Maule Aircraft Corporation

Service Letter #18.
Models Effected M4-220C and M-4-220S
Mandatory on Serial NO's 2001c thru 2025c, 2001S

SERVICE LETTER #18

THROTTLE CONTROL

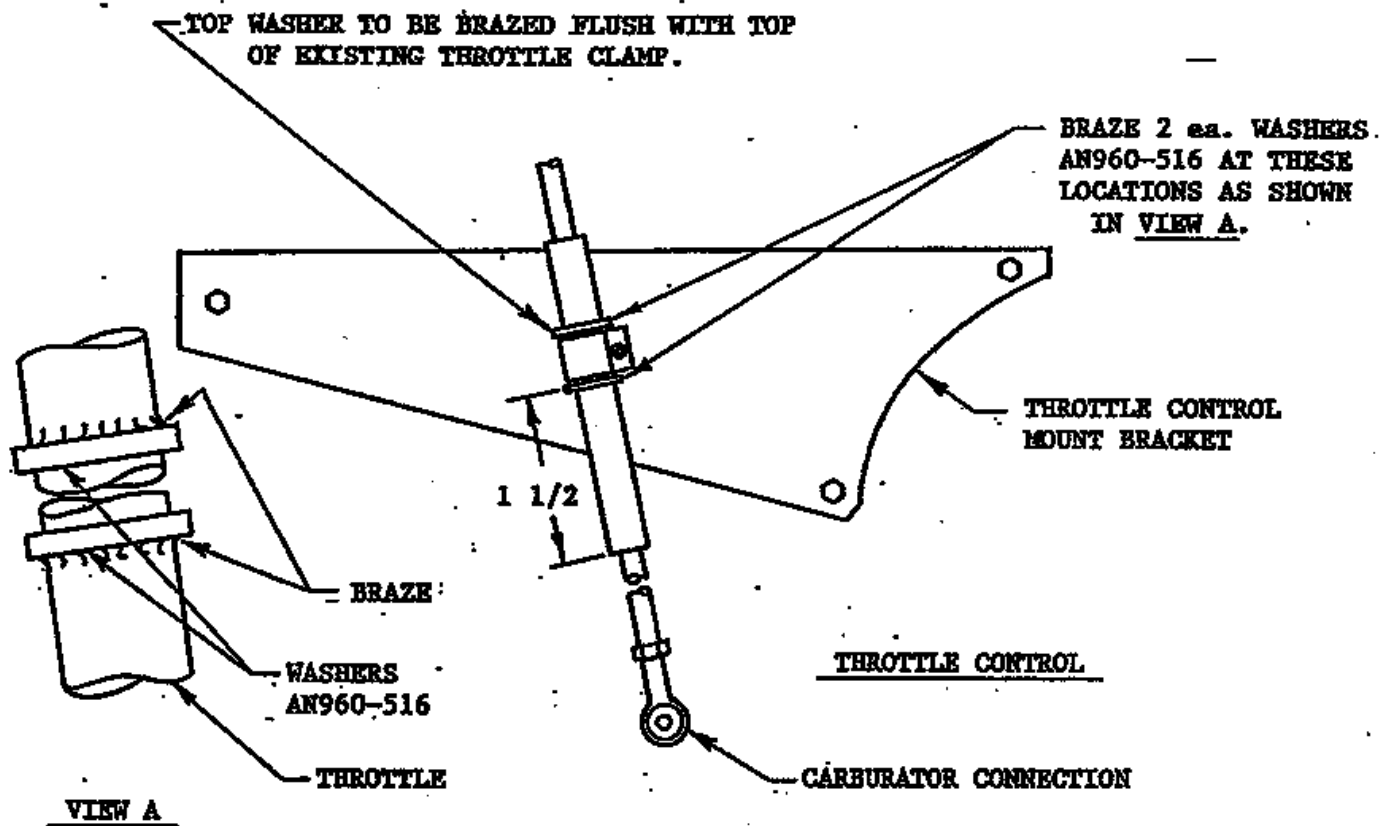
We have discovered a possible malfunction of the throttle linkage attachment.

This Service Letter is to be complied with within the next 30 days. Please fill out enclosed card and return at time of compliance.

CAUTION: DO NOT OVERHEAT WHEN BRAZING WASHERS.

NOTE: LUBE SHAFT WITH LIGHT WEIGHT ENGINE OIL AFTER BRAZING.

2 ea. AN960-516 WASHERS
